Belt tensioner

for Mercedes Benz CDi engines
ref. no. 611 200 04 70

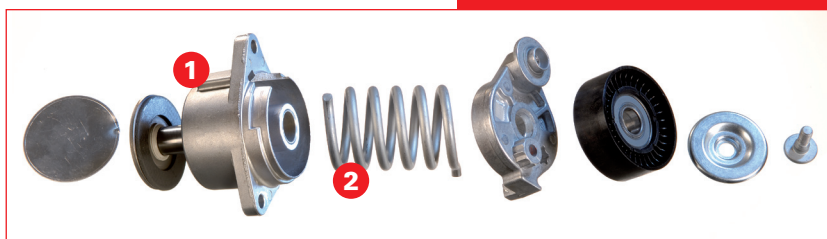
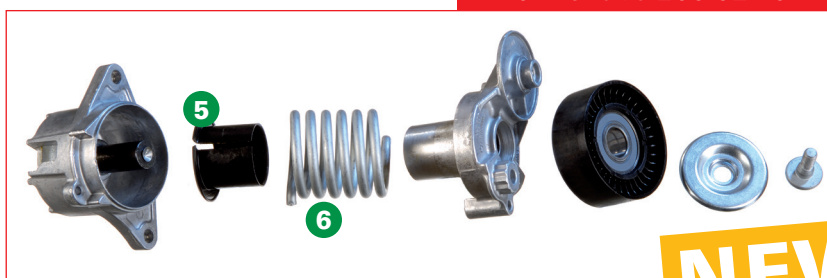
For design reasons, when the vehicle is driven with the original version of the belt tensioner installed (ref. no. 611 200 04 70), noise may occur. (The manufacturer has now replaced this version.)

The noise is generated because the spring is too long and makes direct contact with the base of the housing (1). Only the spring's torsional characteristics are important for this application (2), (6).

The noise is caused when the spring touches the cast-in hollow pin (3) and the base of the housing (4).

febi supplies the belt tensioner febi no. 26775 (ref. no. 646 200 02 70) for the free aftermarket.

A highly wear-resistant plastic bushing (5) distance the spring from the base of the housing and prevents metal-to-metal contact where the spring is located. Since only the springs' torsional characteristics are important the height has been reduced (6).

The spring makes contact with the plastic bushing (7) and is therefore prevented from touching the base of the housing. No noise can therefore occur. In the new version (8), a steel pin has been cast in the base of the housing in order to center the spring.
